Ottawa LRT Independent Review Report

April, 2022
Confidential

Mott MacDonald has been engaged by the City of Ottawa ("City") to provide Independent Review ("Independent Review") services regarding the Confederation Line LRT Stage 1 Light Rail Transit project (the "Project"), designed, built, and maintained by the Rideau Transit Group "Project Co."

Figure 4.27: Wheel Flange Lubrication Location

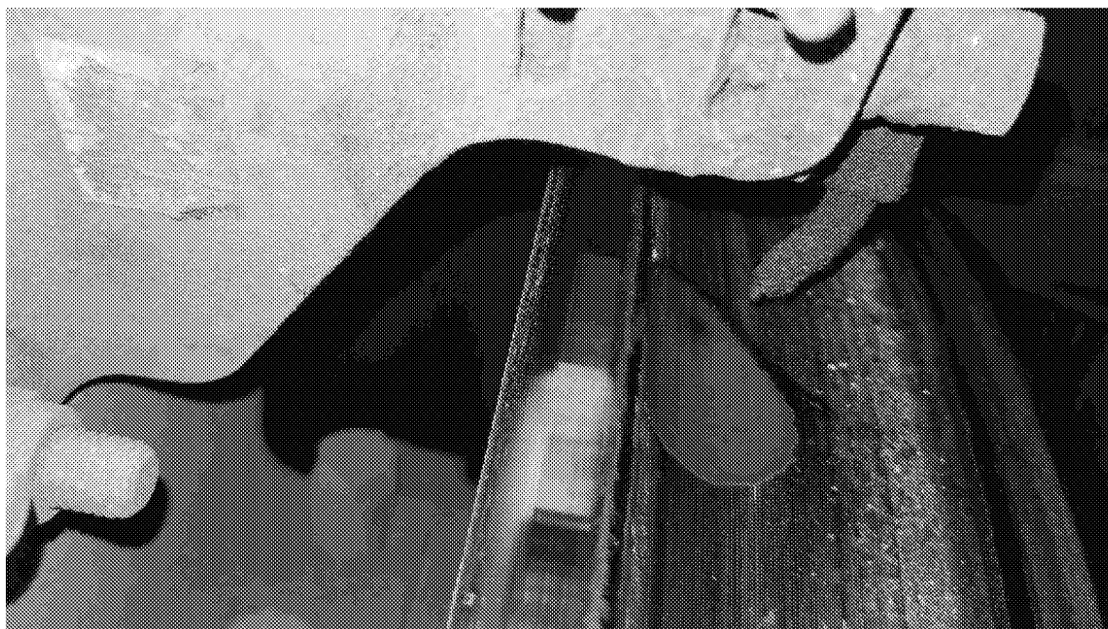
the gap (page 7 of 17, item h.) between the spray nozzle and the outer diameter of the wheel, however this procedure fails to identify the location of the spray nozzle. The procedure refers to the location of the systems mounting block and its distance from the wheel not the spray nozzle. As shown in the image below (**Figure 4.27**), the alignment and volume of oil delivered by this system can easily apply an amount of oil that leads to the wheel tread having oil in an undesirable area leading to wheel slide situations arising.

A one-off check and correction adjustment of the flange lube nozzles, in accordance with the OEM requirements, should be completed across the fleet now, and, subsequently, checks should be carried out to confirm the correct alignment of the flange lubricator spray nozzles after all wheel reprofiling/changing is completed, due to the wheel diameters being reduced/increased. We note that numerous vehicles have undergone wheel truing over the last year to remove wheel flats, which could mean that many spray nozzles are incorrectly aligned. In addition to a one-off fleet check, we recommended ensuring that the correct OEM requirements and any special tooling are available to the Project Co maintenance staff, and ensure that the Project Co maintenance staff have undergone the correct level of training to carry out the adjustments.
